Docket Item # 6  
BAR CASE # 2009-0096

BAR Meeting  
June 3, 2009

**ISSUE:** Alterations  
**APPLICANT:** Alexander St. Clair and Julia Egy  
**LOCATION:** 404 Jefferson Street  
**ZONE:** RM/Residential

Figure 5. Detail of proposed simulated divided light (7/8 inch muntin).

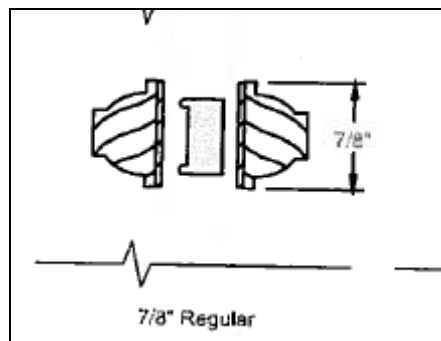
The applicant is requesting approval of a Certificate of Appropriateness for replacement windows on the front elevation of 404 Jefferson Street. The existing windows are non-historic double-glazed vinyl windows with sandwich muntins. The proposed replacement windows are Pella Architect Series double-glazed, simulated divided light wood windows to match the existing in light configuration. Four windows will be double-hung and the window at the basement will be an awning style. The proposed windows will have a 7/8 inch muntin with an interior spacer bar and exterior applied muntins.
